BULLETIN T-64-1

SUBJECT: SPITFIRE SPEEDOMETER CABLE RUN

BULLETIN T-64-3

SUBJECT: LAYCOCK OVERDRIVE

FIG. 1

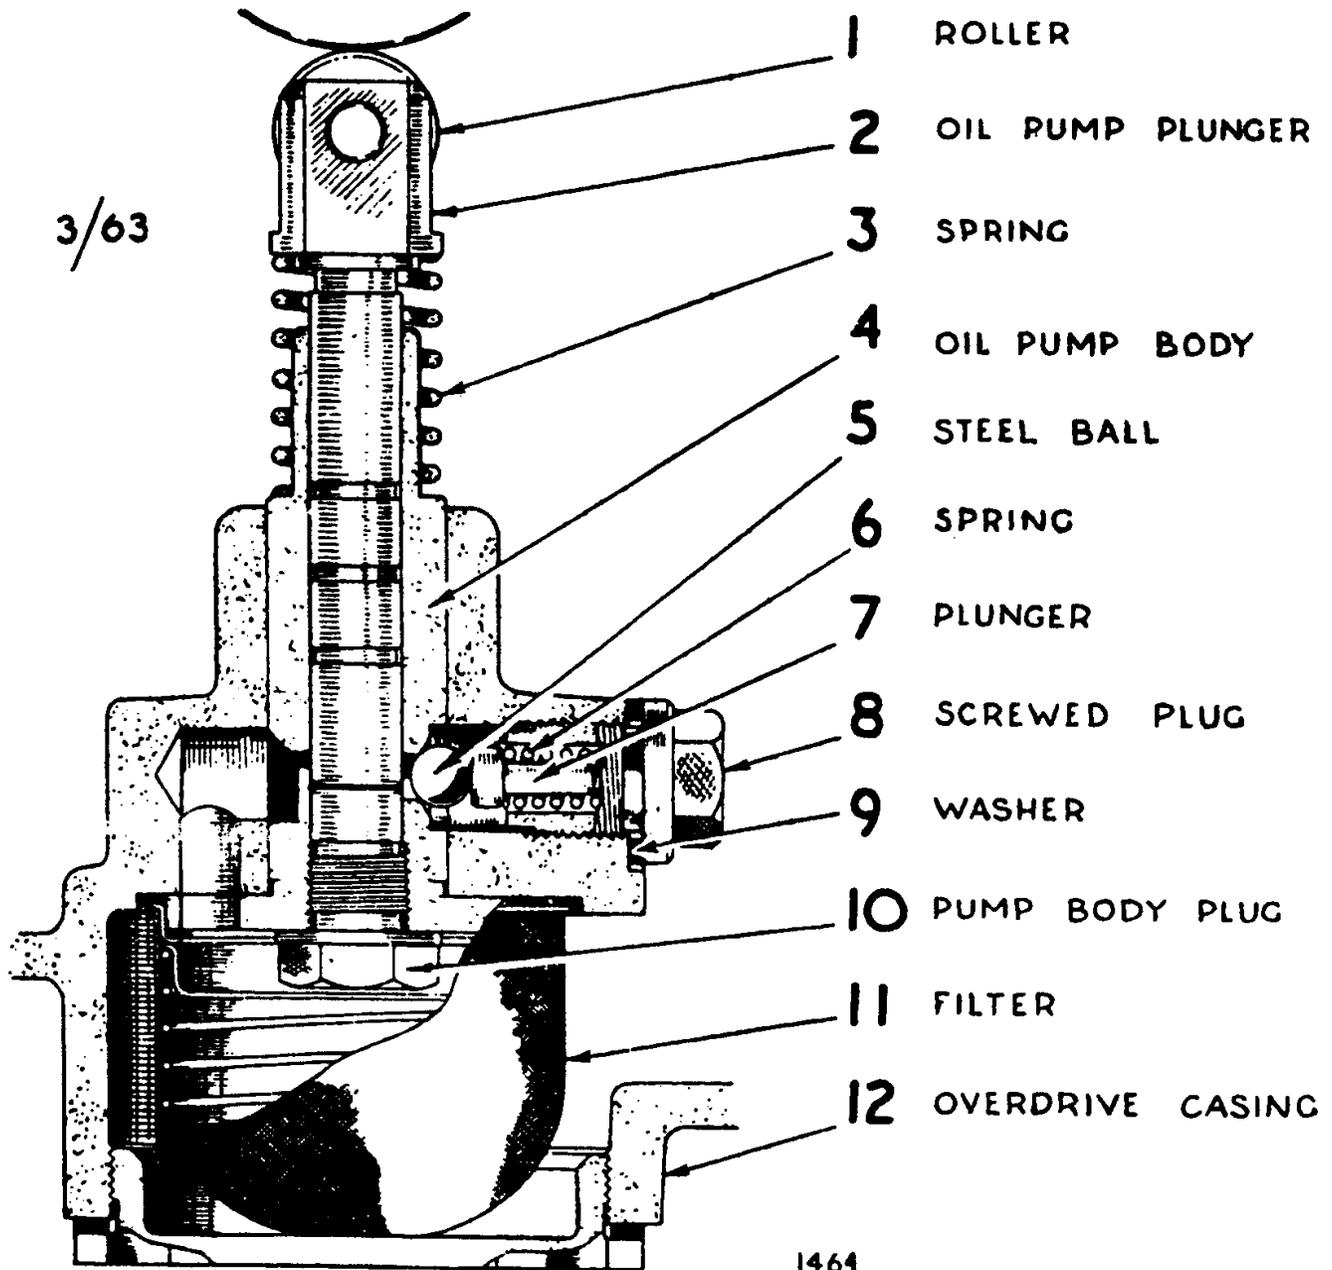
For adjusting the solenoid on "D" type see Service Bulletin 1-63-60. PUMP NON-RETURN VALVE (Figure 1)

In "A" type units access to the valve necessitates removal of the solenoid and solenoid bracket. The bracket is secured by two 5/16" (7.937 mm.) diameter studs and two t/16" (7.937 mm.) diameter bolts, the head of the bolts being painted RED. THE NUTS MUST BE REMOVED FROM THE STUDS BEFORE TOUCHING THE BOLTS. The two bolts should not be slackened off together releasing the compression on the accumulator spring which abuts the solenoid bracket.

After removing the valve plug, spring, plunger and ball, clean the seat and reset the ball by giving it a sharp tap with a suitable hammer and drift.

FIG. 2

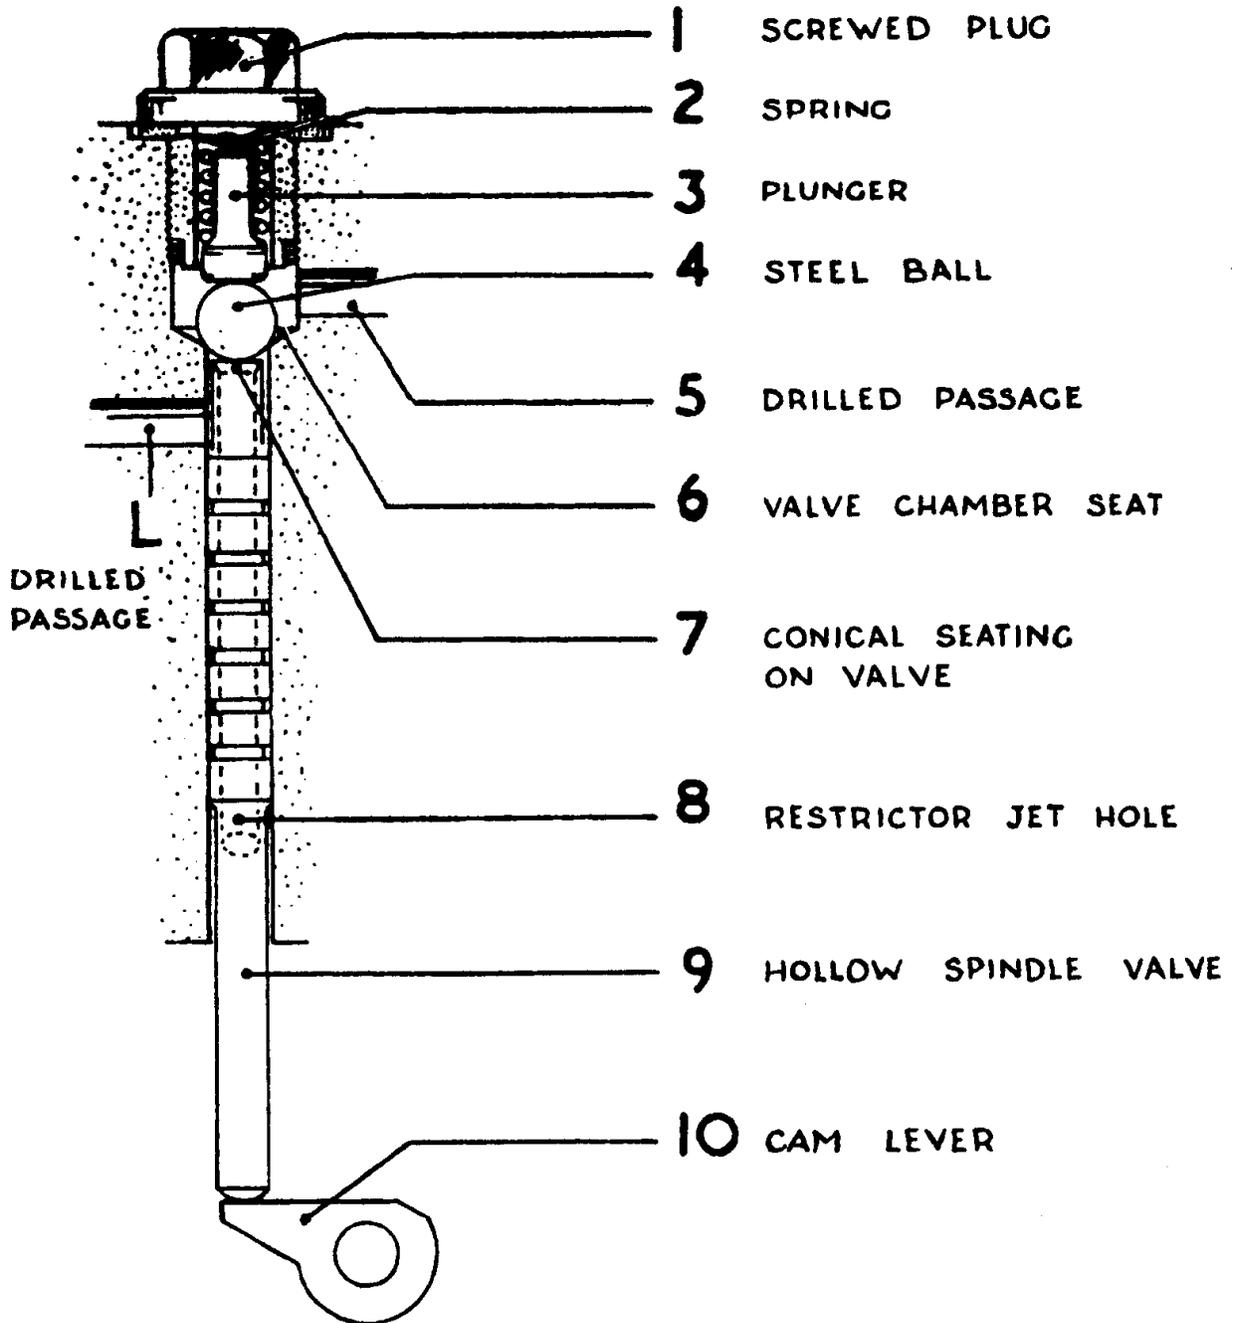
The operating valve plug is located on top of the unit. Release hydraulic pressure, unscrew plug and remove spring, plunger and ball. A small magnet will be found useful for this operation. Remove operating valve by inserting a stiff piece of wire and drawing it up. Near the bottom of the valve will be seen a small hole breaking through the center drilling. Ensure that this is not choked (Figure 2).

If necessary, the ball can be resealed on top of the operating valve by placing the ball on a block of wood and sharply tapping the valve after positioning it on the ball. Clean the valve seat in the casing and if necessary reseat the ball by tapping it gently on its seat with a copper drift. Do not tap the ball too hard or the mouth of the hole will be closed up so that the valve cannot be reassembled.

FIG. 1.

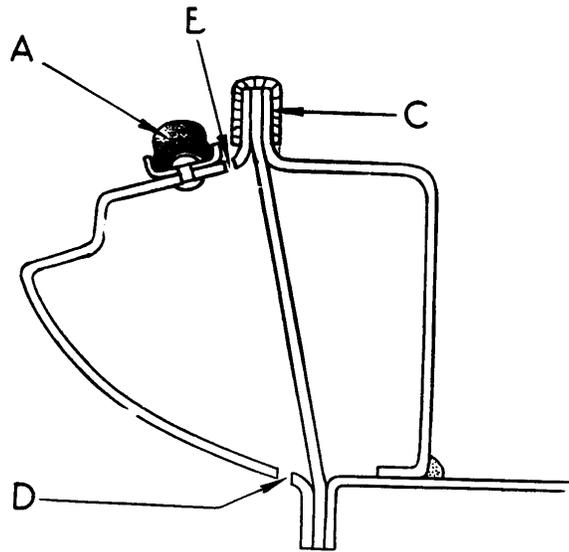
8. To prevent a build up of water at the base of the door, early cars were fitted with a separate door rubber seal inserted in a channel pop-riveted to the door aperture. "A" Fig. 1. Assist the drainage by drilling three equidistant 3/16" die. holes in the top of the body sill panel in-board of the riveted channel at the bottom of the door aperture. "B" Fig. 1. To allow drainage from the body sill, a drain hole 1/4" dia. should be drilled at the rear wheel arch end of the outer sill panel at its lowest point. "C" Fig. 1

The later type of door aperture sealing rubber, part No. 707931, which combines the aperture sealing rubber and aperture flange finisher may be fitted. "D" Fig. 1. The original channel for the older type rubber should be retained as the new rubber fitted to the aperture flange will almost conceal it.

FIG. 2.

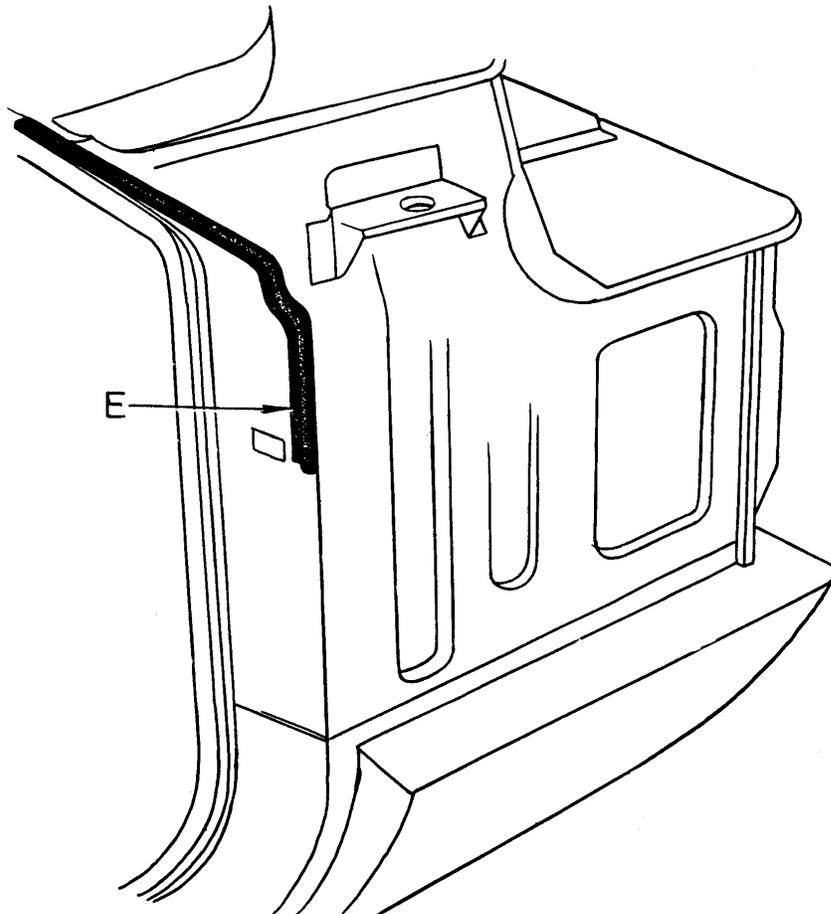
10. A "P" section rubber, part number 651842, as now fitted to the "A" post and screen pillar, allowing each coat to dry before applying a further coat. Brush sealer be fitted to any car not so equipped by attaching with a suitable adhesive. See Fig. 2 "E" for correct positioning of rubber to screen pillar and "A" post.

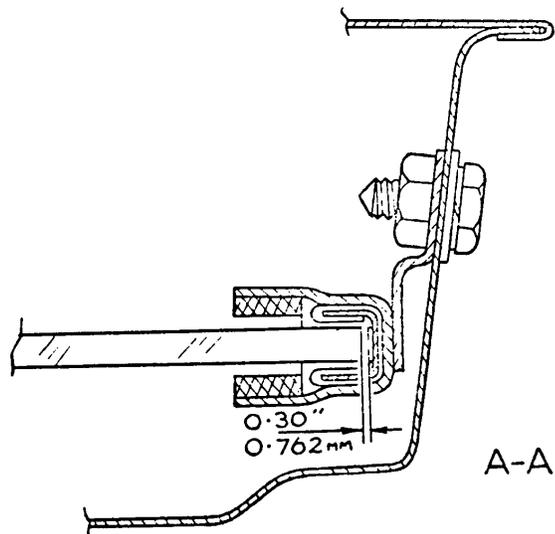
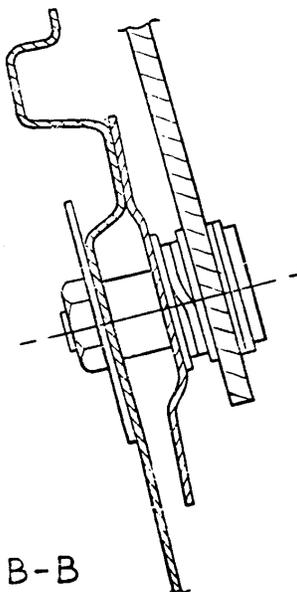
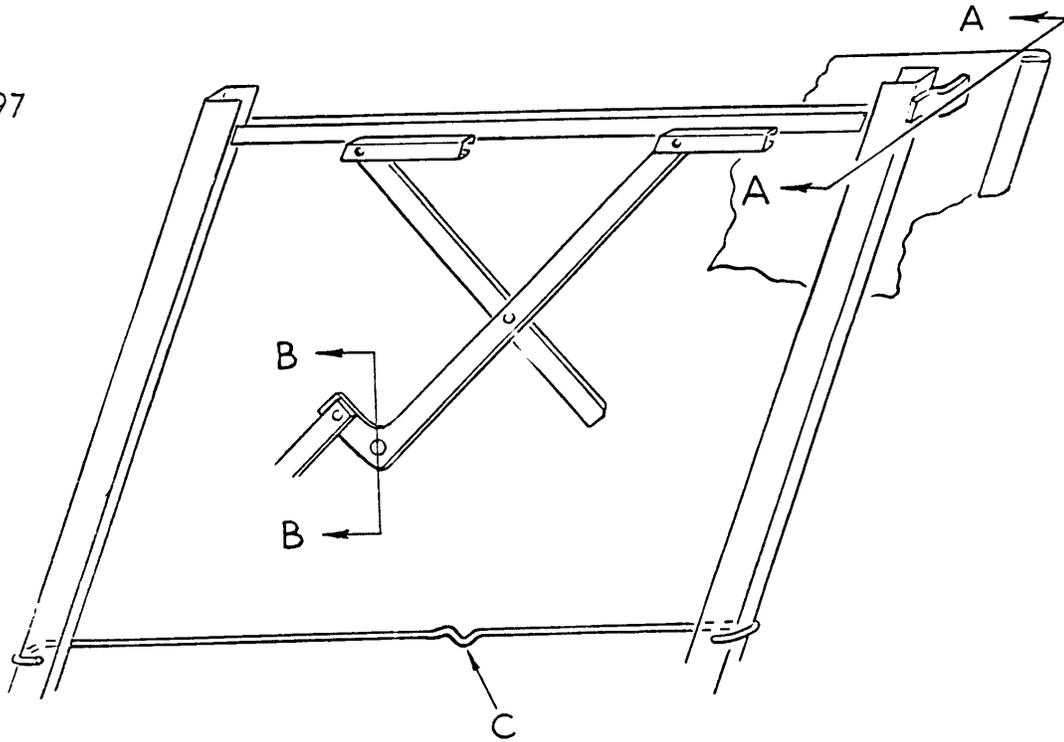
1. Remove trim panel.
2. Raise window and check the clearance of the glass fore and aft in the top of the rear channel. The recommended clearance is .030" which should be maintained for the whole length of the channel. Excess clearance will allow tilting and the jamming of the glass and insufficient clearance will produce stiff operation. Clearance can be obtained by the use of packing washers between the inner door panel and top channel bracket (see illustration A-A).

3. Adjust bottom brackets and crimp the tie rod to ensure that the channels are parallel (illustration C).
4. Remove regulator pivot pin nut and delete spring washer under head of nut. Add washer WP0119 1/2"x 7/8" x .050" behind head of pivot bolt and additional washer WP0160 5/16" x 1 5/8" x 16 S.W.G. behind head of nut (illustration B-B).

5. Tighten nut sufficiently to allow ease of operation and peen or center pop end of thread.
6. Refit trim.
